<b>Office Action Summary</b>	<b>Application No.</b> 10/634,369	<b>Applicant(s)</b> THOMPSON, PAUL S.	
	<b>Examiner</b> Shumaya B. Ali	<b>Art Unit</b> 3771

**Claims 1-3 are rejected under 35 U.S.C. 102(b) as being anticipated by Salter et al. US 4,106,505.**

Prior Art  
US 4,106,505

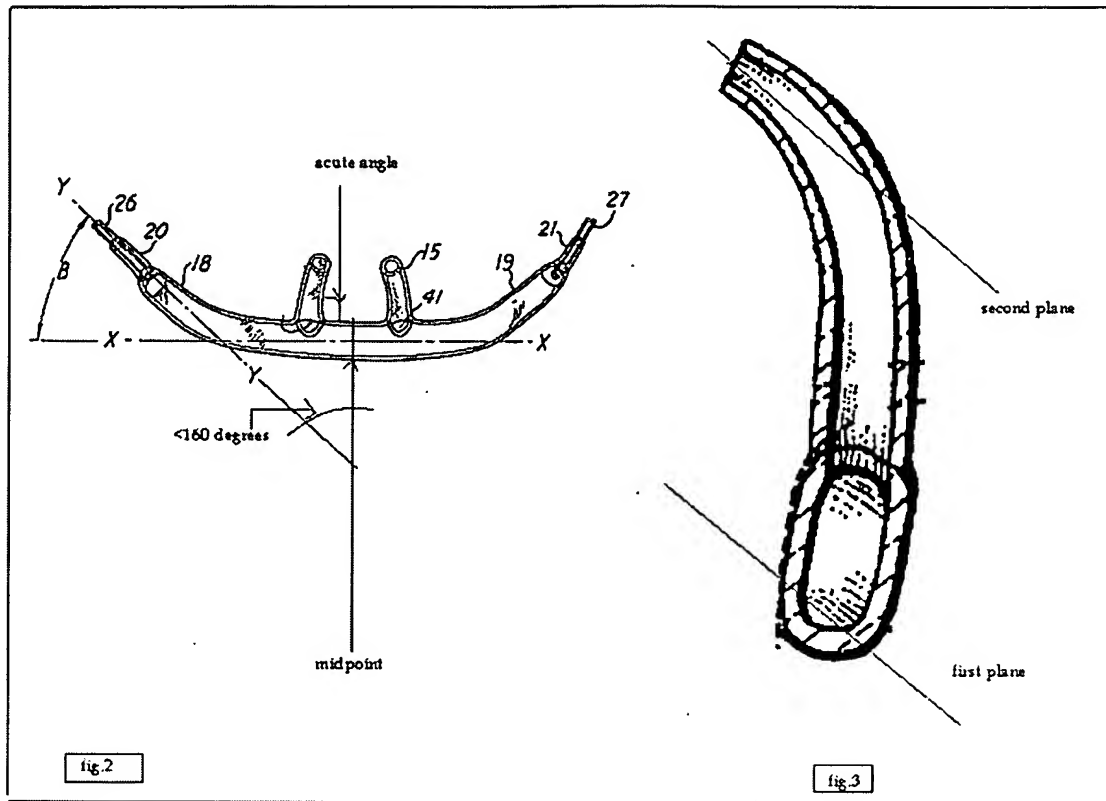
gas directing orifices and which hollow portion of said extensions communicate with said hollow main body portion (13), said central portion lying in a first plane (see labeled fig.3, attached below) with longitudinal axes symmetrical about a midpoint and forming an angle in said first plane less than 160 degrees, each said hollow extension having a longitudinal axis projecting from said central portion at an arcuate angle (see col.2, lines 25-27; labeled fig.2, attached below) from said first plane, said gas directing orifices of said hollow extensions having a longitudinal axis lying in a second plane (see labeled fig.3, attached below) essentially parallel to and displaced from said first plane, said end portions of said central portion lying in essentially the first plane with longitudinal axis of said end portion essentially collinear with longitudinal axis of corresponding symmetrical half of said central portion (see labeled figs.2 and 3, attachment below), said end portion of said central portion laying in essentially the first plane with longitudinal axis of said end portion essentially collinear with longitudinal axis of corresponding symmetrical half of said central portion (see fig.2).

**As to claim 3**, Salter discloses wherein longitudinal axis of each said gas-directing orifice angled acutely in said second plane toward second said gas directing orifice (see labeled figs. 2 and 3, attached below).
